Informations and comments on **ECE-TRANS-WP.29-GRB-2016-02e**

Louis-Ferdinand PARDO (France)

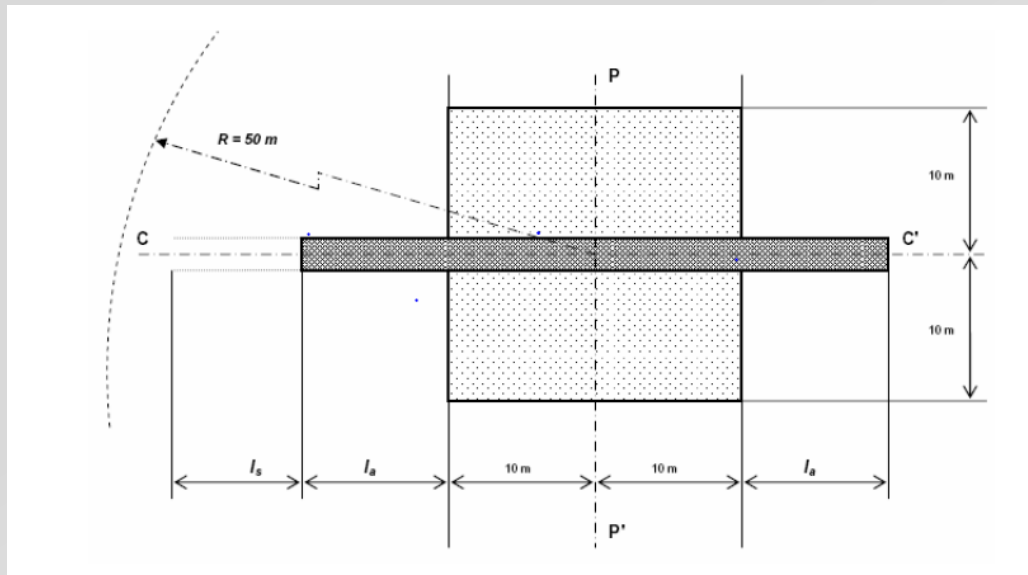
→ 6.2 refers to anechoic environment only. Reference on open space are only on in a note :

→Test could be done in open space or in semi-anechoic chamber

●●● Part I – 6.3.2.

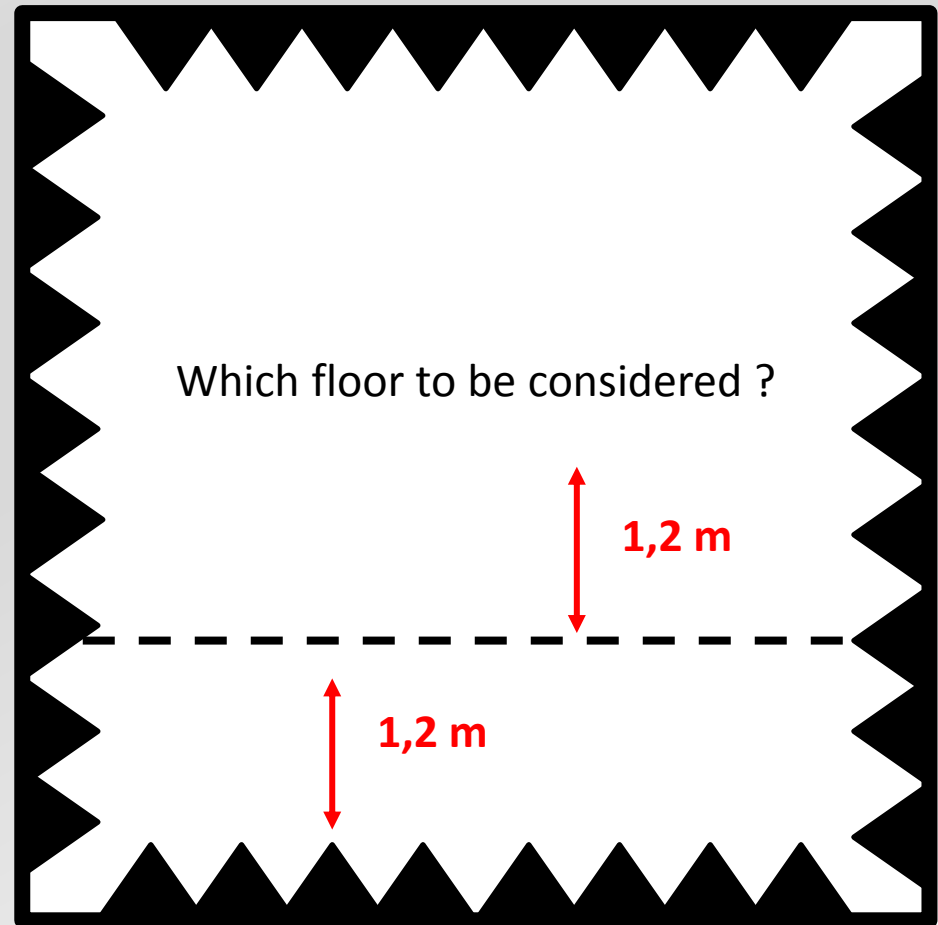
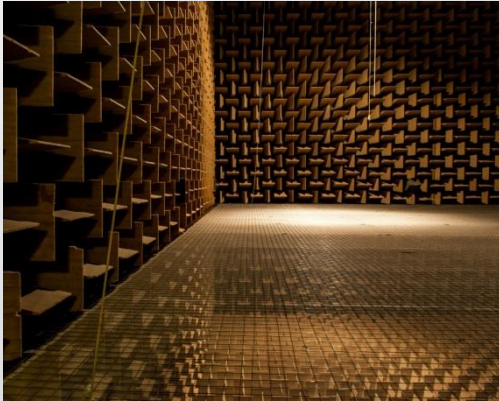
→ In an anechoic environment, only the distance between the device and microphone is important if :

- minimum distance to the absorber ($\lambda/4$) is respected,
- it corresponds to a microphone transverse.

●●● Part I – 6.3.2.

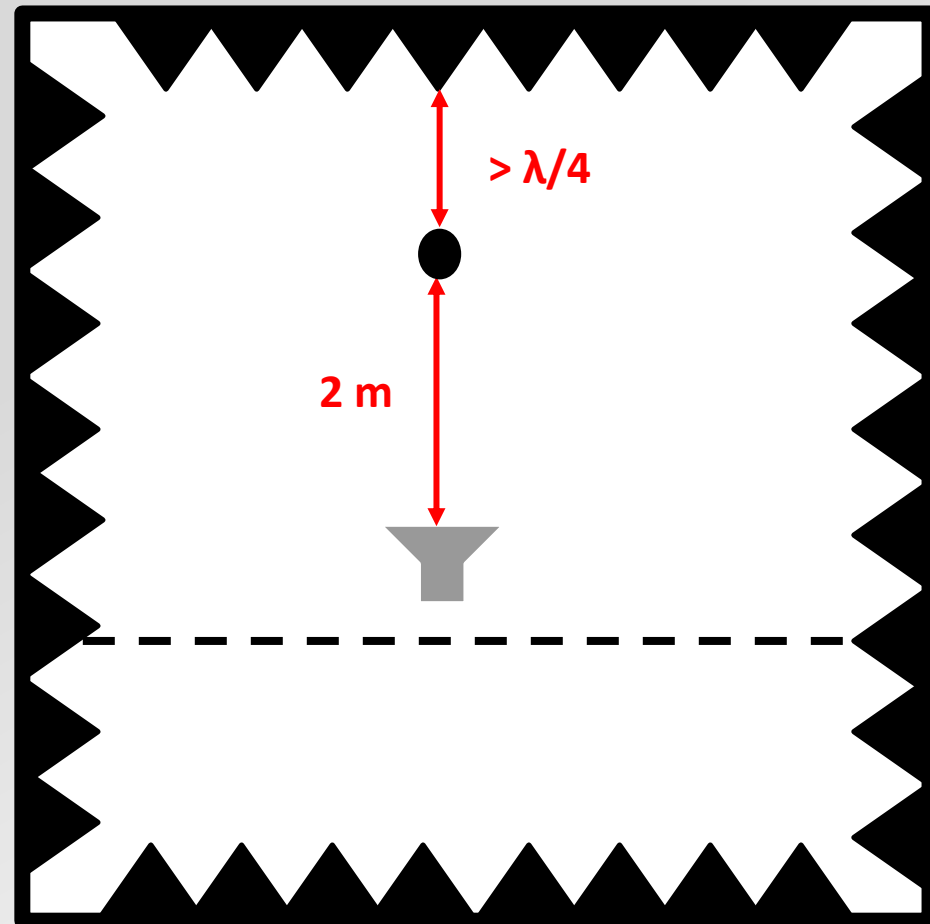
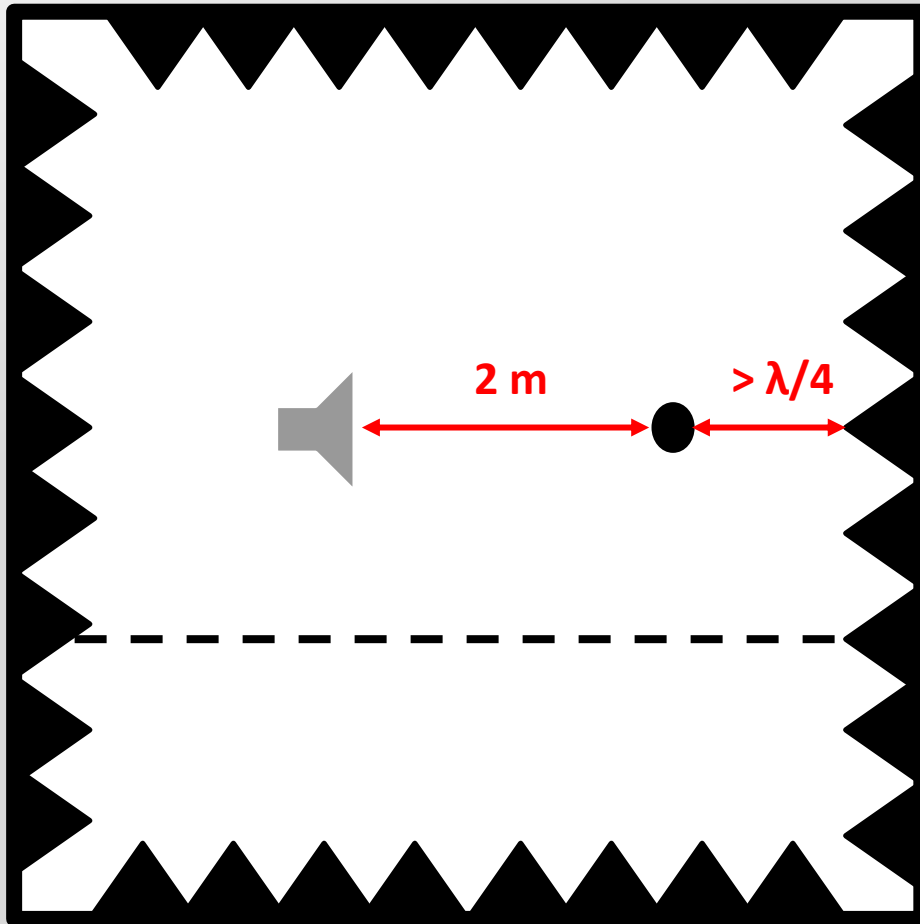
Both example should be valid :
